UNITED STATES PATENT AND TRADEMARK OFFICE

APPLICATION NO.	FILING DATE	FIRST NAMED INVENTOR	ATTORNEY DOCKET NO.	CONFIRMATION NO.
10/719,743	11/21/2003	Bernard J. New	X-1141 US	3152
24309	7590	11/02/2005	EXAMINER	
XILINX, INC ATTN: LEGAL DEPARTMENT 2100 LOGIC DR SAN JOSE, CA 95124			NGUYEN, HAI L	
			ART UNIT	PAPER NUMBER
			2816

DETAILED ACTION

FIG. 3

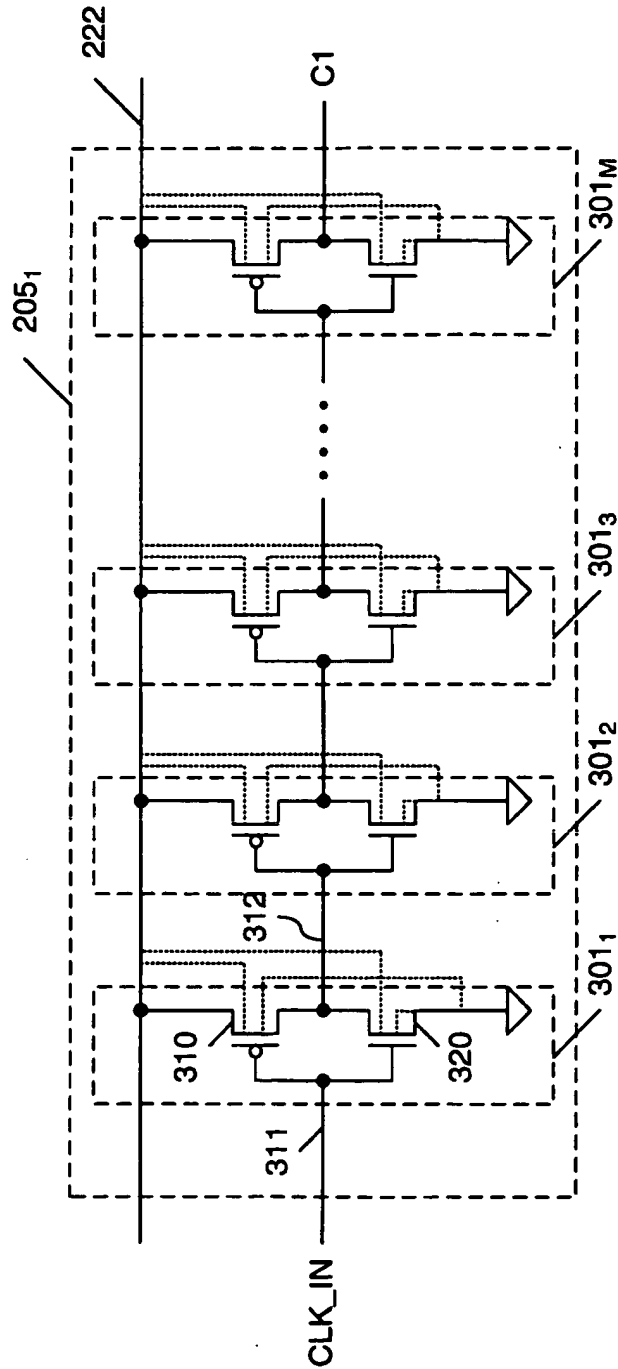
As to Applicant's request about the confirmation of the previous objection to the drawings, Examiner's confirmation is that the objection to the drawings has been withdrawn. The replacement sheet of drawings, filed on 02/14/2005, has been approved.
